DYSON ESTATES SUBDIVISION, FIRST ADDITION, RESUBDIVISION OF LOT 1

APPLICATION NUMBER 19 DATE May 6, 2004

DETAIL SITE PLAN

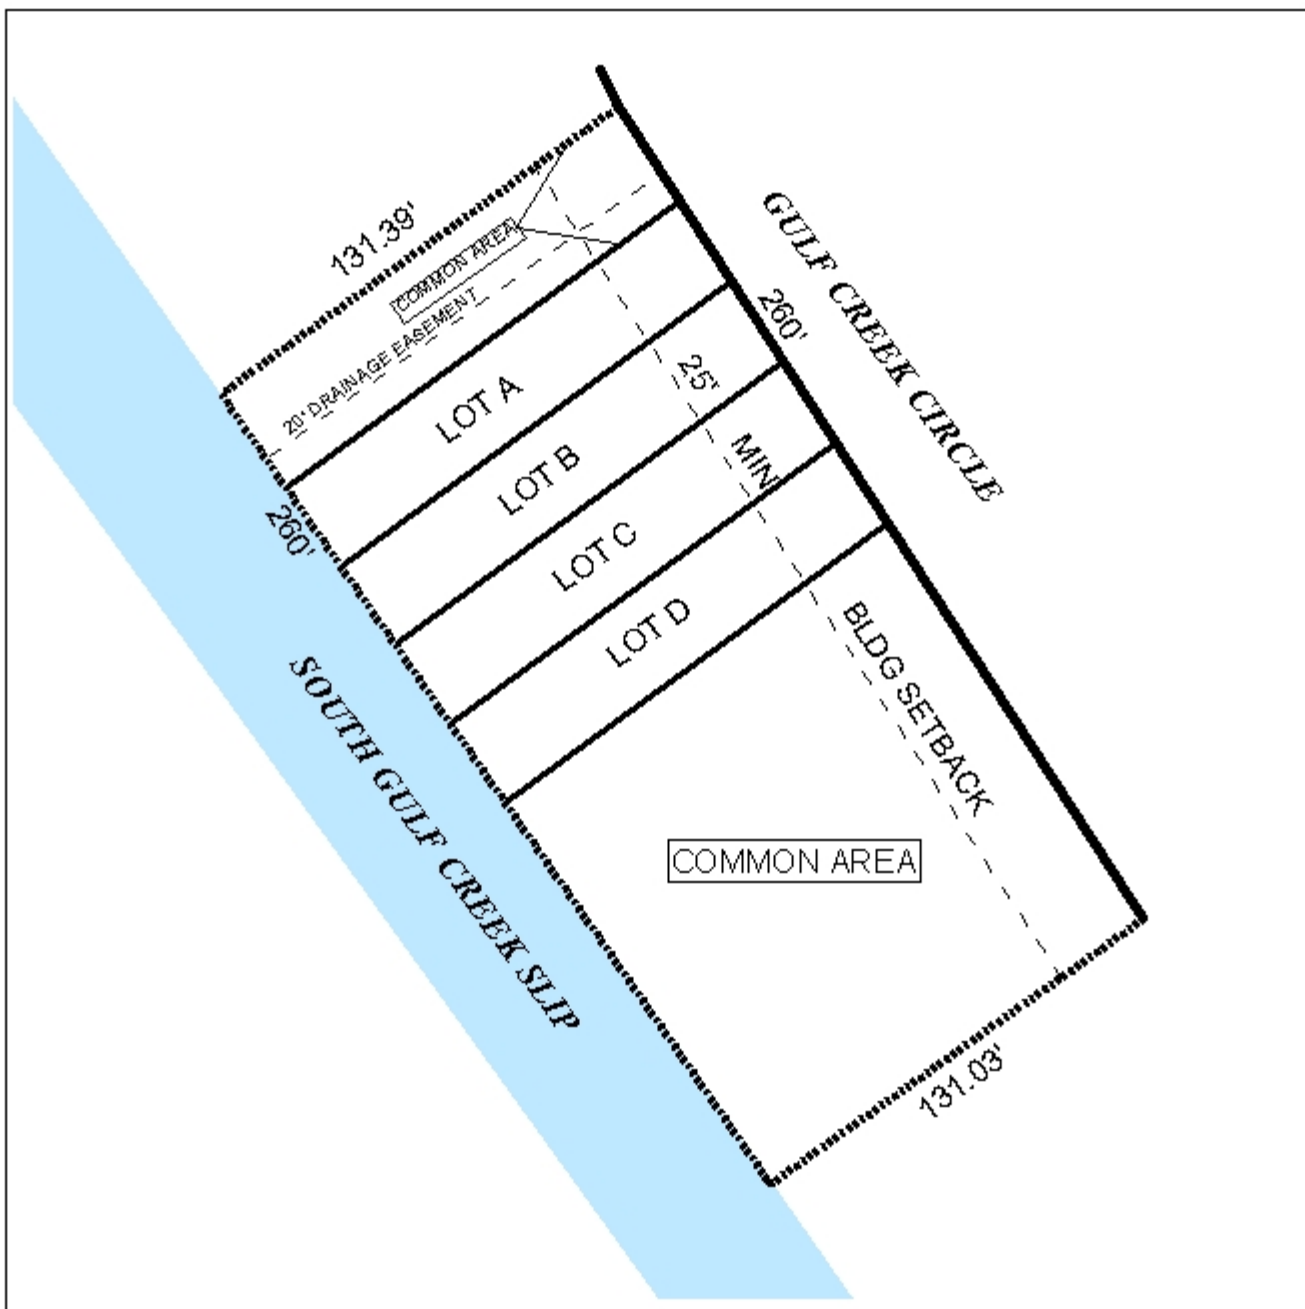
The proposed lots will consist of privately owned boat slips and contain approximately 1,250 square feet of area, therefore a waiver of V.D.2. would be required. Additionally, there are two common areas shown on the plat that contain 20,700 square feet, thus providing additional usable area for the site. It should be noted that the Commission has waived minimum lot size requirements in unusual situations such as billboard sites and lots for utility substations. In this situation, there is additional common area that would be usable open space. To ensure this open space remains combined with the lots, a note should be placed on the final plat stating that there will be no further resubdivision of the site. Furthermore, a note should be placed on the final plat stating that residential use is prohibited on the lots and common areas.

Two common areas are shown on the plat, thus the placement of a note on the final plat stating that maintenance of the common areas shall be the responsibility of the property owners should be required.

This site is located in the County, thus a note should be placed on the final plat stating that since the lots will not be developed residentially, a buffer in compliance with Section V.A.7. of the Subdivision Regulations must be provided where the site adjoins residential development.

With a waiver of Section V.D.2., the plat will meet the minimum requirements of the Subdivision Regulations and is recommended for Tentative Approval subject to the following conditions: 1) the approval of all applicable federal, state and local agencies; 2) the placement of a note on the final plat stating that there will be no further resubdivision of the site; 3) the placement of a note on the final plat stating that a buffer, in compliance with Section V.A.7. of the Subdivision Regulations, will be provided where the site adjoins residential development; 4) the placement of a note on the final plat stating that residential use is prohibited on the lots and common areas; and 5) the common areas be indicated on the final plat with a note stating that the maintenance thereof is the responsibility of the property owners association.
